Proof of Evidence - Design

**Land north of Cambridge
North Station, Cambridge**

PINS Reference: APP/W0530/W/23/331561

Annemarie de Boom MSc on behalf of
South Cambridgeshire District Council

Figure 1 Land use distribution

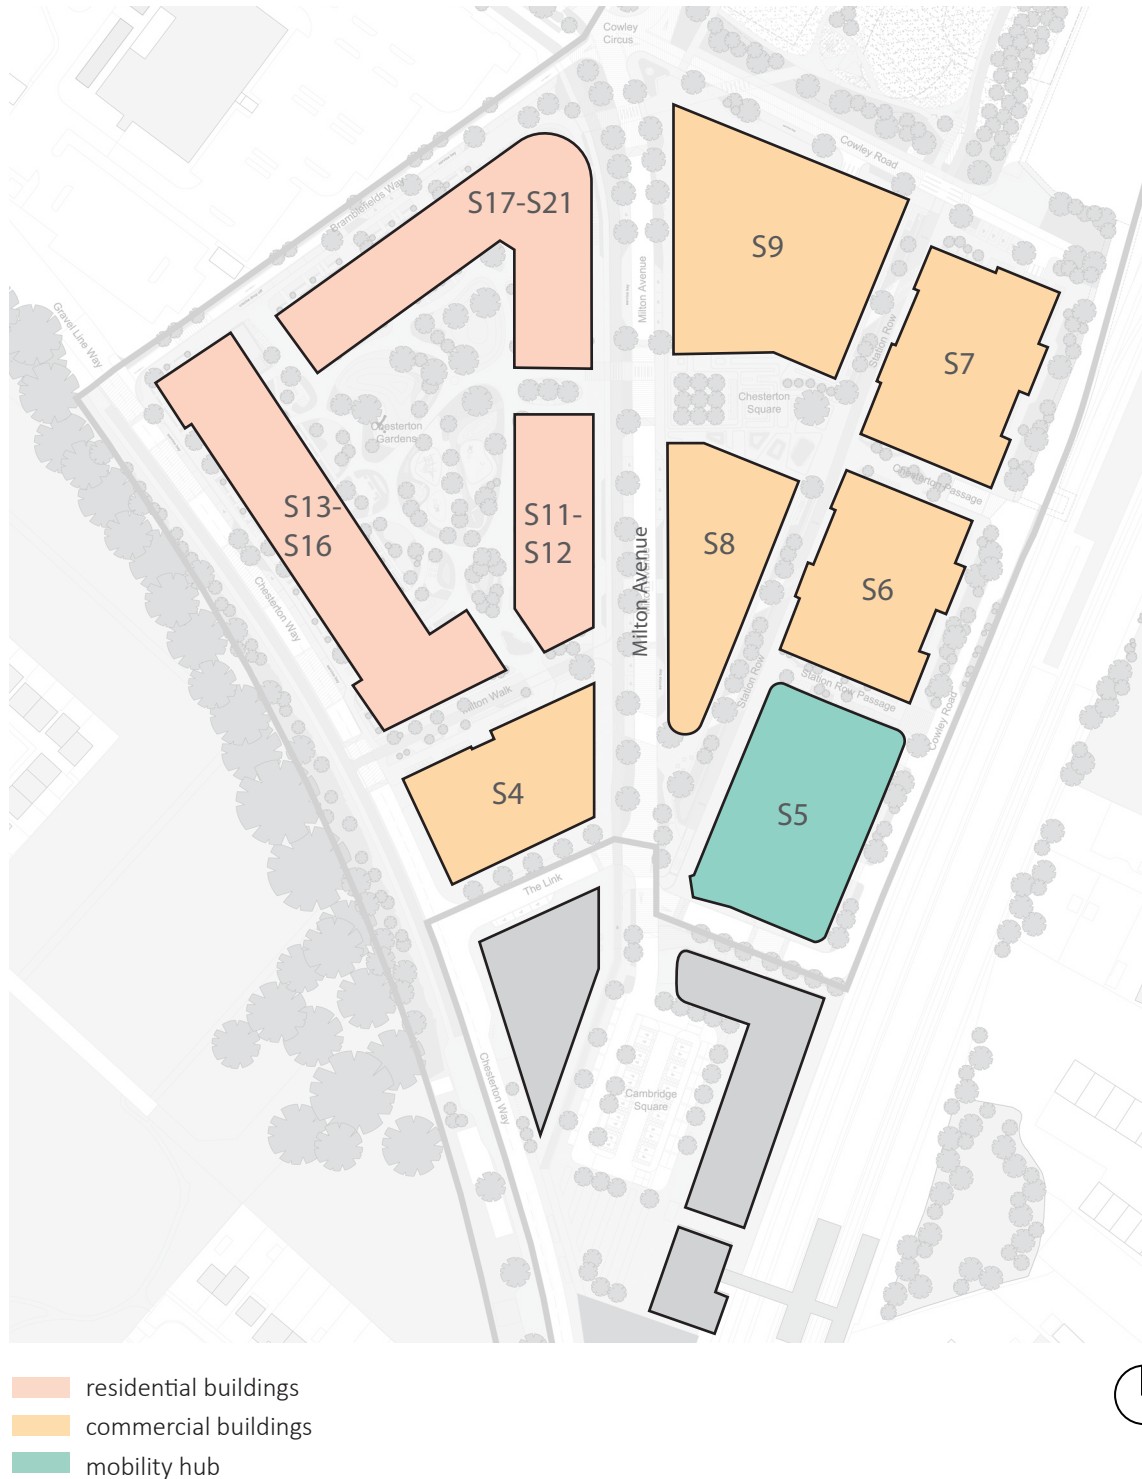
5.9 Milton Avenue broadly divides the scheme into two parts. All residential development is located west of Milton Avenue and most of the commercial developments is proposed to the east as shown in Figure 1 Page 17.

- 5.11 The design of the proposed commercial buildings at Cambridge North is driven by the need for large, regular floor plates. This has resulted in large footprint buildings that fully occupy the proposed urban blocks with a single building. In comparison to residential developments, there generally is less scope in commercial developments to add visual interest and a human scale to the elevation designs (i.e. through the introduction of windows of different shape and sizes, integrated and / or projecting balconies, a higher density of front doors on the ground floor etc). Thus, even well-designed commercial developments tend to result in larger and more monotonous buildings than (well-designed) residential developments.

Figure 2 Front doors as an indicator of the density and variety of ground floor activation

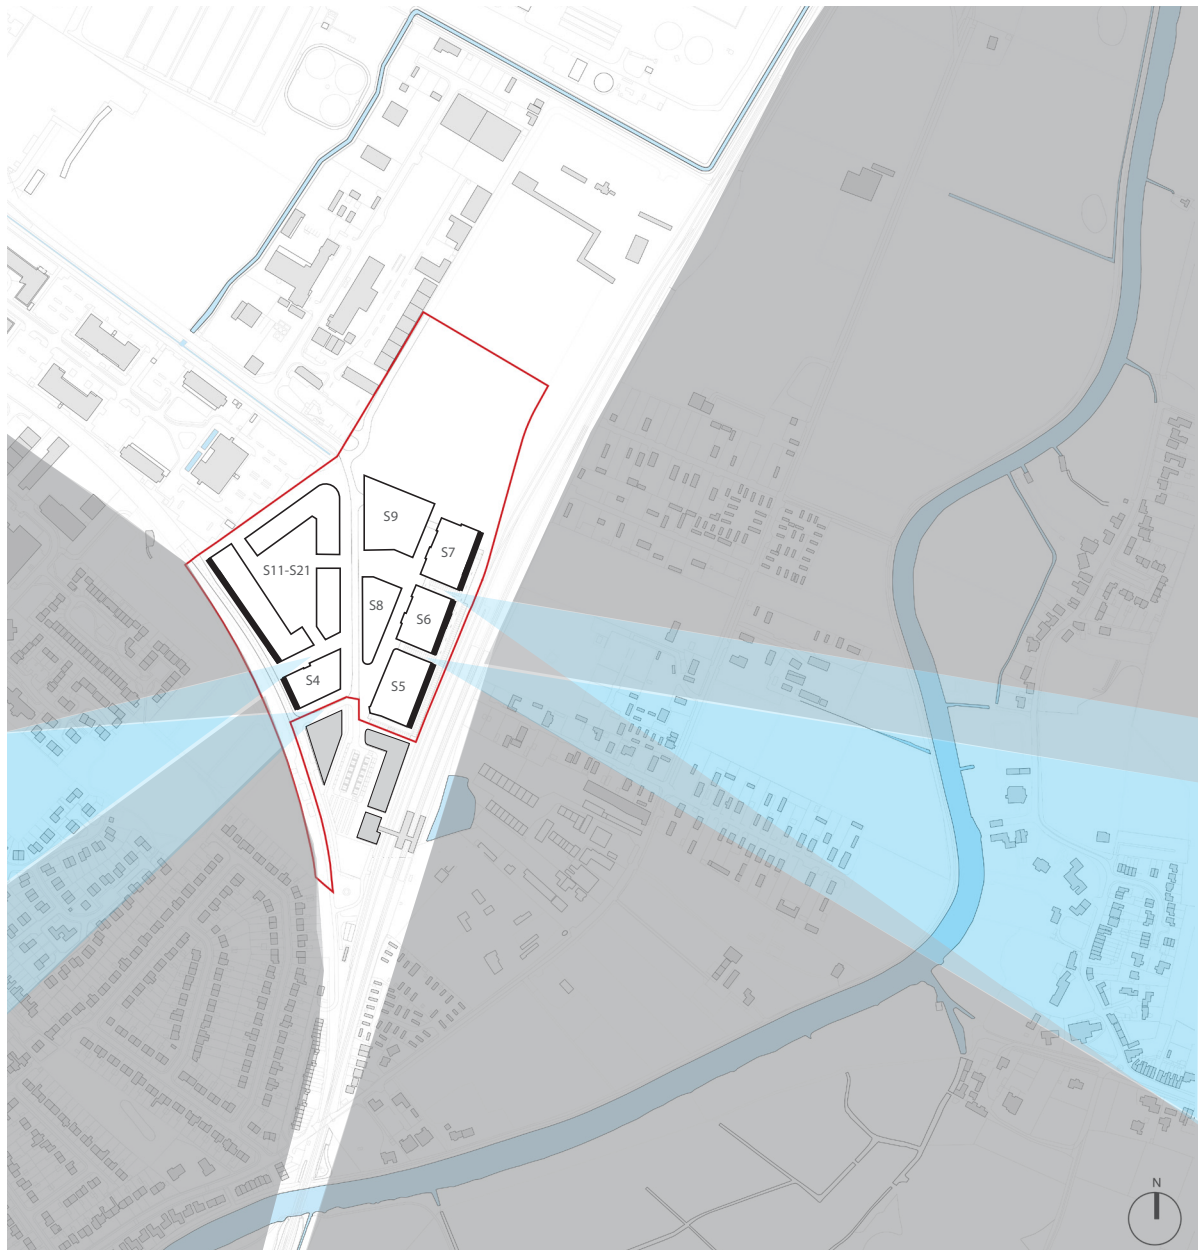
- 5.15 Although this is supported in principle, the spaces allocated for Class E/F uses in S4, S6 and S7 are relatively large with just one or two units provided along the full length of the block. This would not provide the level of variation and intensity of activation required to adequately animate the long streets and large public spaces as illustrated in Figure 2 Page 19 (the number of front doors and use type is used as an indicator of the density and variety of the proposed ground floor activation).

5.17 The Design and Access Statement make repeated references (through reference images) to the London Kings Cross development as an example of the envisaged design and activation of the public realm. However, the footfall and amount and diversity of land uses at Kings Cross are not comparable with the appeal scheme. Yet the scale and design of streets and spaces in both schemes is similar. The lack of people to “fill” these large areas of hard landscaping will result in a lack of comfort and animation of the public realm.

Figure 11 Design interpretation of 1 Cambridge Square

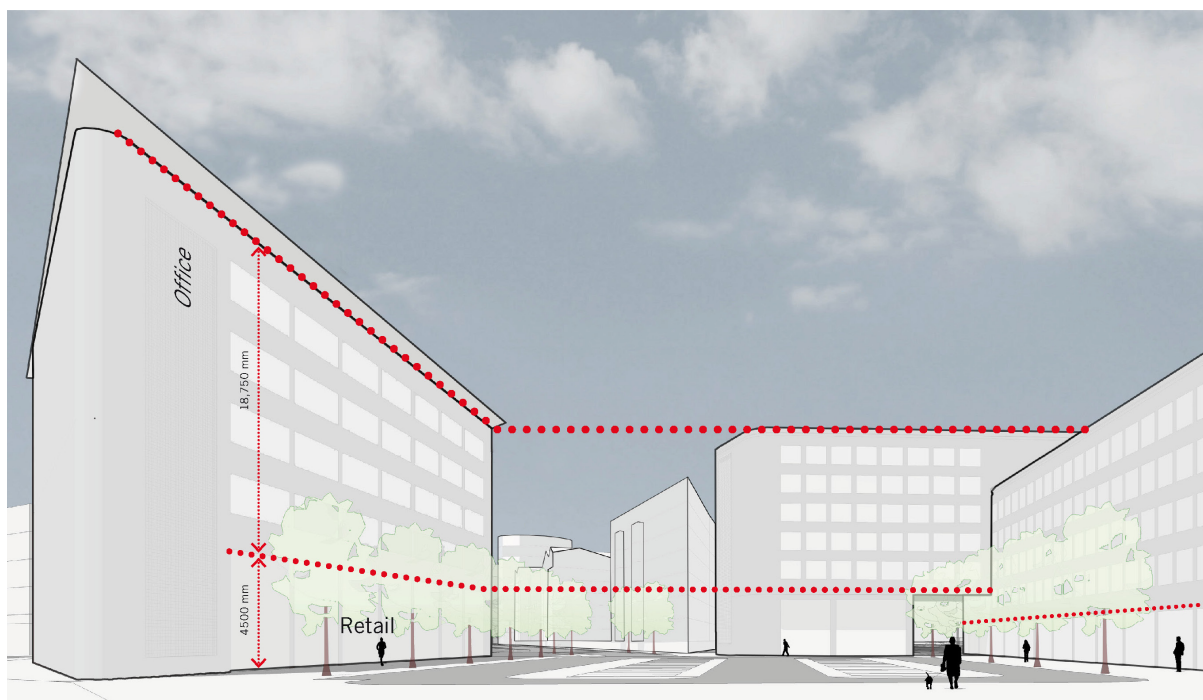
- 5.36 The visually dominant upper edge of 1 Cambridge Square is formed by the red brick volume. In my opinion, the height of the brick edge should form the reference when determining the appropriate height of a new building that seeks to mediate to a lower adjoining building. This view is shared by the architects of 1 Cambridge Square which made this proposition when determining the height of 1 Cambridge Square in reference to 2 Cambridge Square as shown in Figure 11 Page 27.

Figure 12 Context elevation of S4 along Milton Avenue

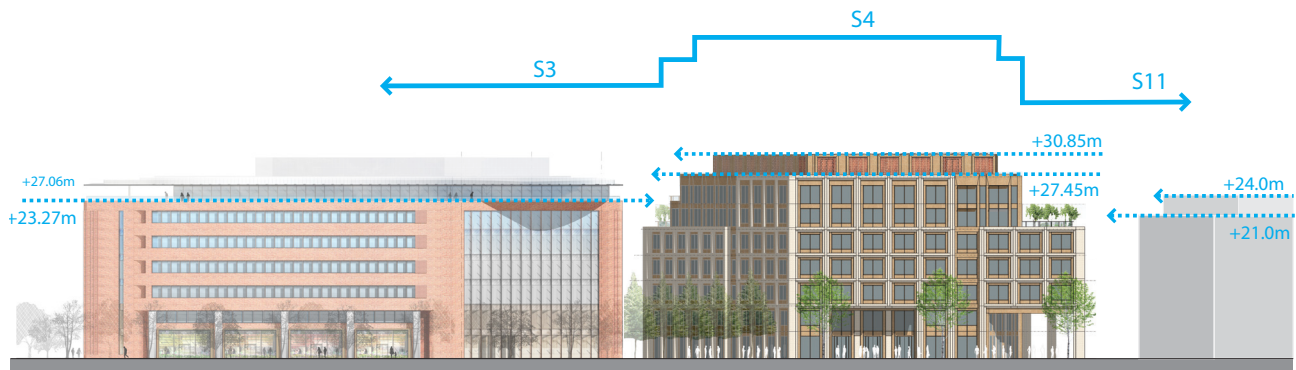
- 5.37 Instead, the proposed top floor of S4 extends to 27.91m which is 4.18m - more than a full storey - above that of the main volume of 1 Cambridge Square as illustrated in Figure 12 Page 28. The rooftop plant, which is a much heavier and visually prominent feature than that of 1 Cambridge Square extends to 30.86m or 7.59 m above the edge of the red brick volume.

- 5.38 For the above reasons, the building does not successfully fulfil its intended role as a mediator to the lower buildings S11-12 to the north.

Figure 13 Scale and massing of S4

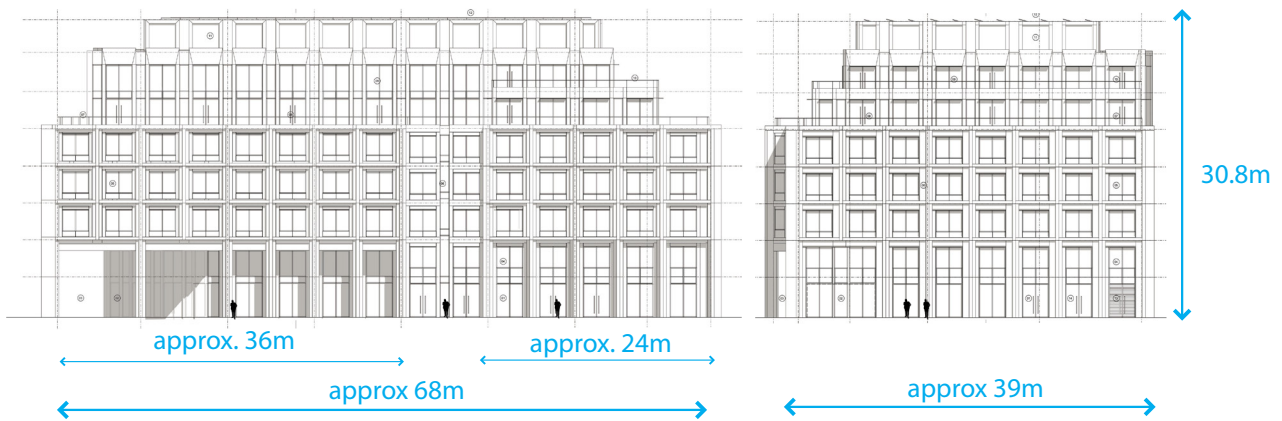
- 5.41 For a more realistic impression of building scale, in Figure 13 Page 29 I have used the black and white elevation drawings provided in the application pack and have added a person at 1.69m to provide the right sense of scale.

- 5.42 As evidenced above, the proposed elevation design fails to successfully break down the massing of the building and result in a lack of human scale. It also fails to achieve the level of diversity and visual interest required to comfortably define and enclose surrounding streets.

Figure 15 Size of people in submitted elevation drawings

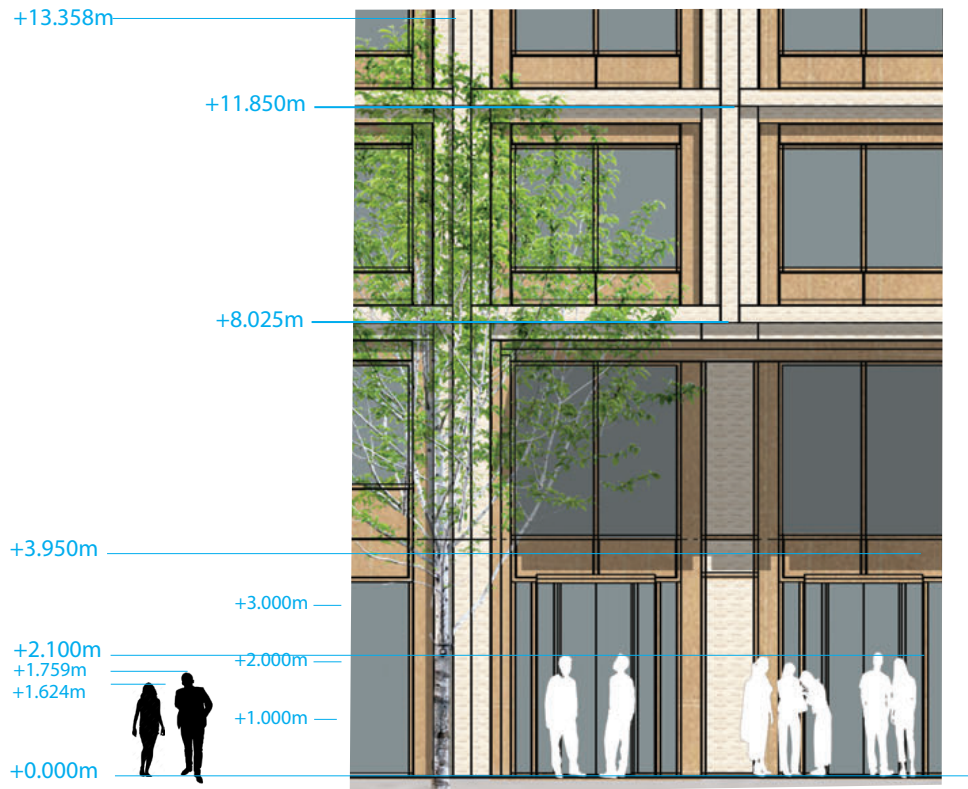
- 5.40 It should be noted that the submitted colour elevation drawings provided as part of the application mistakenly scale people to be 2.1m tall as illustrated in Figure 15 Page 30. This represents a 24% increase on the average height of a person in the UK, which in 2021 was 175.9 cm for men and 162.4 cm for women averaging to 169.2 cm (source [www. statista.com](http://www.statista.com)). This is the equivalent of 7.4 metres or nearly 2 storeys as illustrated in Figure 16 Page 30. The drawing of the trees is also misleading as the shape and proportion is that of a young tree, yet it is sized as a semi-mature tree. This gives the impression that the building is considerably smaller than it will appear in reality.

Figure 17 S4 unbalanced elevation facing Milton Avenue

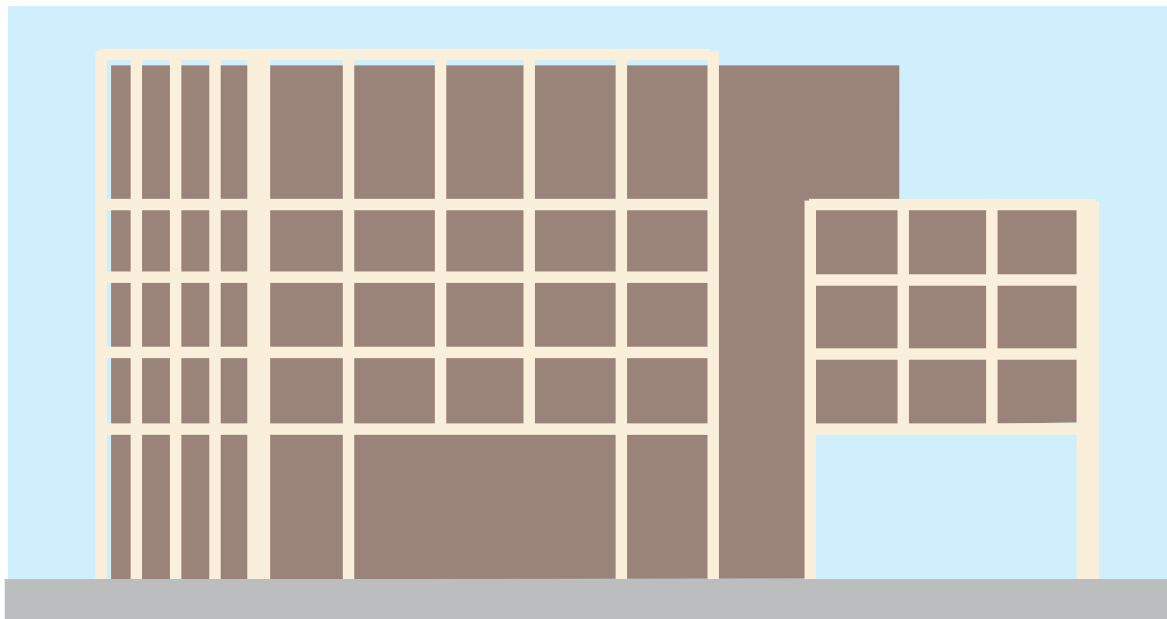
- 5.43 When viewed on the approach from the railway station, the size and proportion of the two visible brick elements of S4 do not feel well-balanced. The element that overhangs and demarcates a cut-through to the residential quarter feels too small in comparison to the adjacent element as is illustrated in Figure 17 Page 31. It does not provide a coherent, place-responsive design, nor create an interesting vista or focal point along this important route. Accordingly, the building is not mindful of its impact on its surroundings.

Figure 18 The back elevation of S4 on Chesterton Way

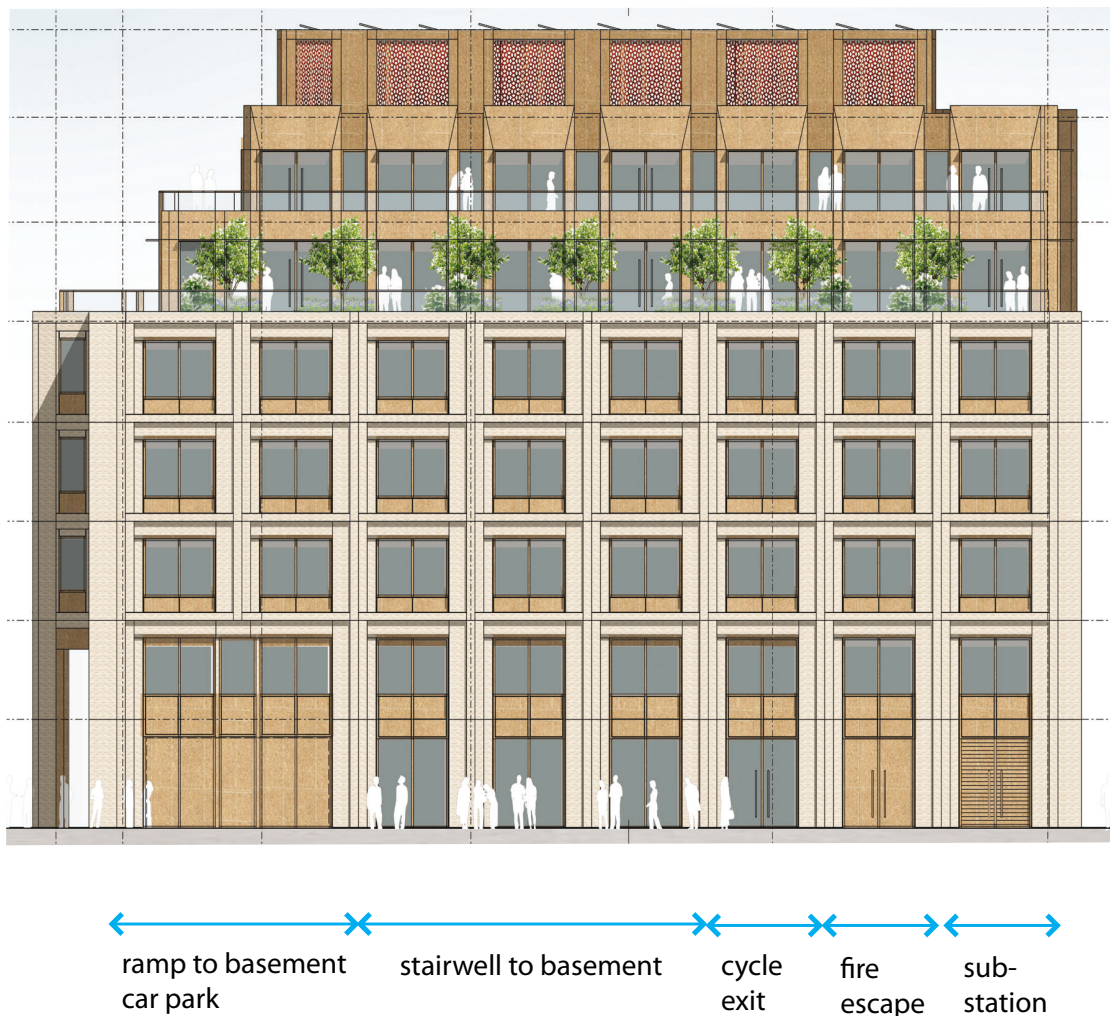
- 5.44 The design of S4 turns it back to Chesterton Way, where the fire exit, entrance to basement car parking, sub station etc are located as illustrated in Figure 18 on Page 32. This will result in a relative poor quality environment, exacerbated by absence of street trees to soften impact. This is not considered an appropriate response to this strategic cycle route.

Figure 22 Relation of S9 with Wild Park

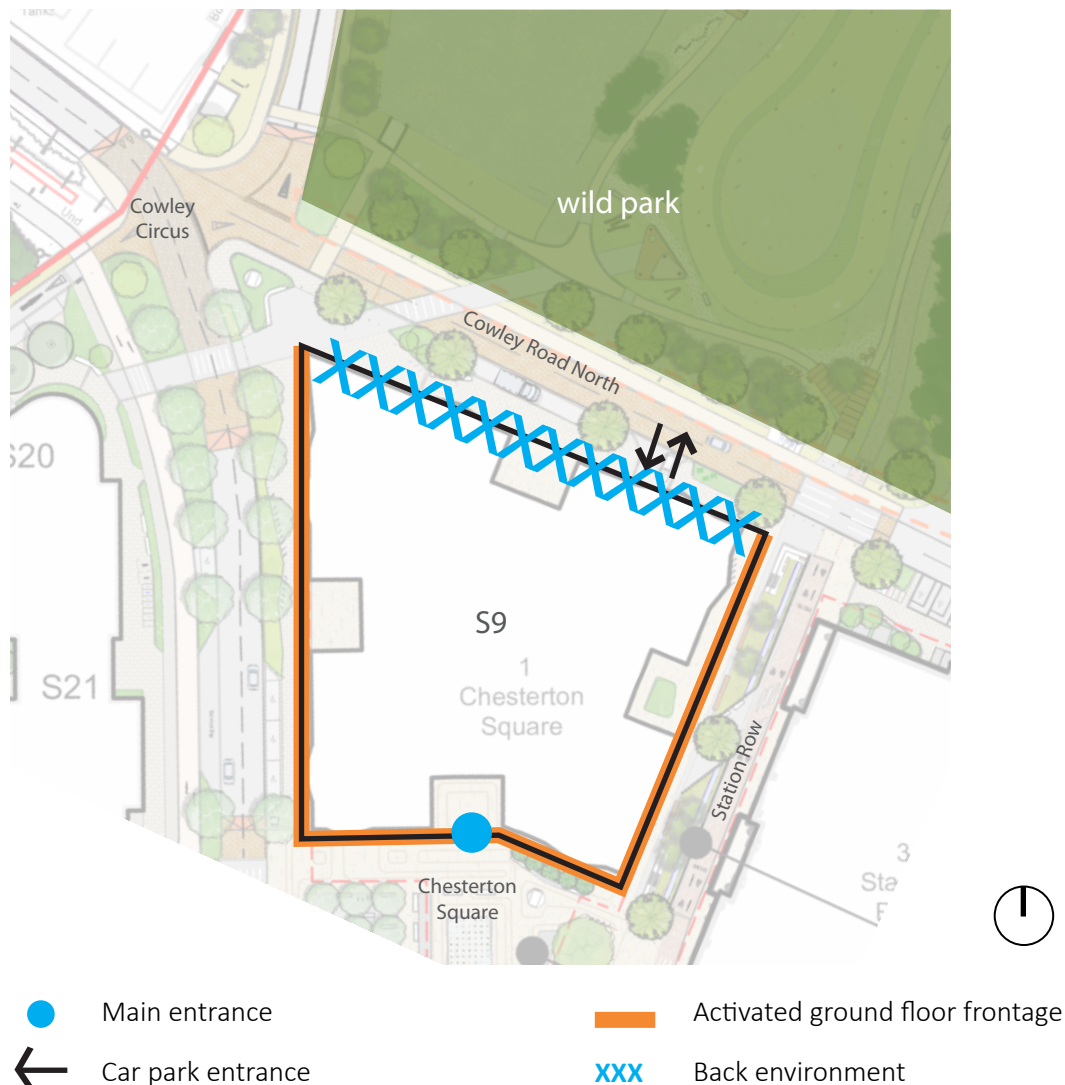
- 5.67 Parameter plan 07 indicates that there is no activation of ground floor sought for the northern side of Building S9. This is also where the entrance to the car parking and plant is located. Thus, it seems to be considered the “back” to the building as illustrated in Figure 22 Page 37.

- 5.68 This creates a sense of confusion about the role and identify of Wild Park. Is this an important open space resource to be used and enjoyed by the future community? If so, a positive and active edge needs to be provided. Or is it an area with primarily an ecological and drainage function? This may make a “back” more acceptable within the scope of this planning application, but this is not compatible with the vision for this space as set out in the wider long term masterplan that includes the redevelopment of land to the north.
